AFDAU-T1

Service Information Letter

SUBJECT: UPDATE TO WIRING DIAGRAM FOR ONBOARD SYSTEMS C40 INDICATOR INTERFACE

Effectivity: All AFDAU-T1 installations interfaced with an Onboard Systems C40 indicator

DIAGRAM 5B - LOADCELL INTERFACES

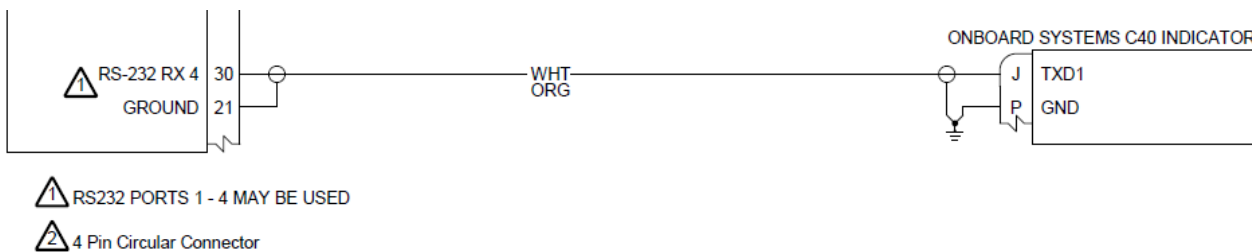
AMS would like to advise a change to Wiring Diagram 5B in the installation manual (P/N: AMS-IM-1-001 Revision 9) which has been updated with a correction. The correction relates to how the ground wire for the C40 to AFDAU-T1 serial bus is connected. Originally it was shown to be connected to Pin L of the C40 Indicator. Advice obtained from Onboard Systems has been that this would be ineffective and may cause a communication issue between the AFDAU-T1 and C40 indicator. The wiring diagram has been changed to a more appropriate configuration, as show below.

Rev 8 Diagram:

Rev 9 Diagram:

AMS recommends no further action is required unless the customer is experiencing communication issues between the AFDAU-T1 and C40 Indicator. Once corrective action has been taken, a final functional check of the system is recommended.
